TRANSMISSION **722.901**

P27.10-2139-06

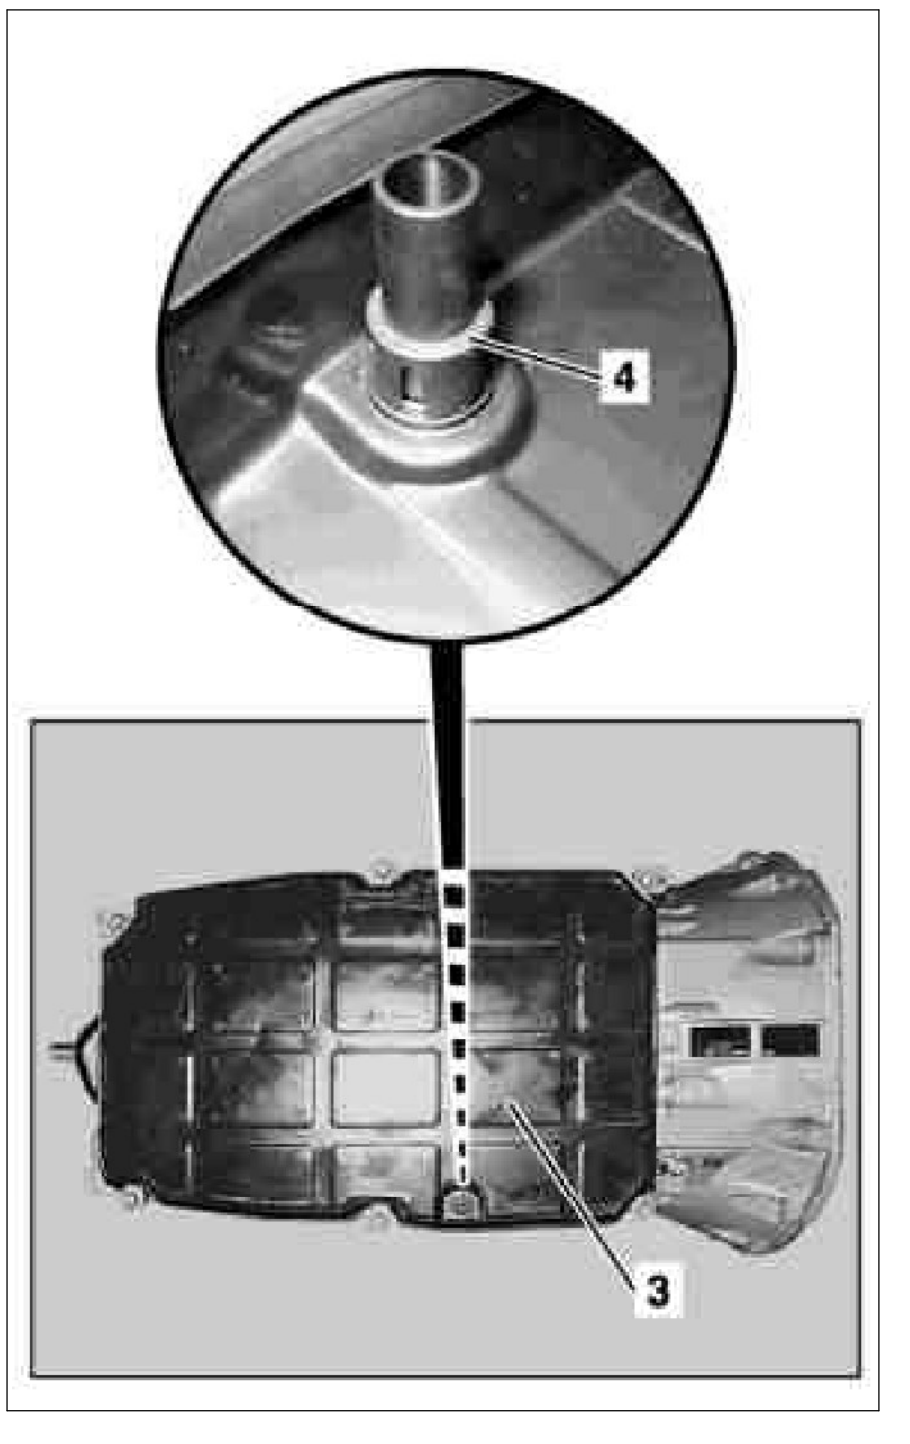
To improve fluid supply to the transmission, the transmission oil pan and the overflow tube have been redesigned.
The characteristic sloped surface (arrow) can be used to identify the new oil pan (1). This oil pan configuration should be installed only together with the white overflow tube (2).

The fluid temperatures used as references for checking and refilling are different with the new components.

Whenever a transmission is removed for repairs, the earlier oil pan (3) with the black overflow tube (4) should be replaced by the new sloped-surface version (1) with the white overflow tube (2).
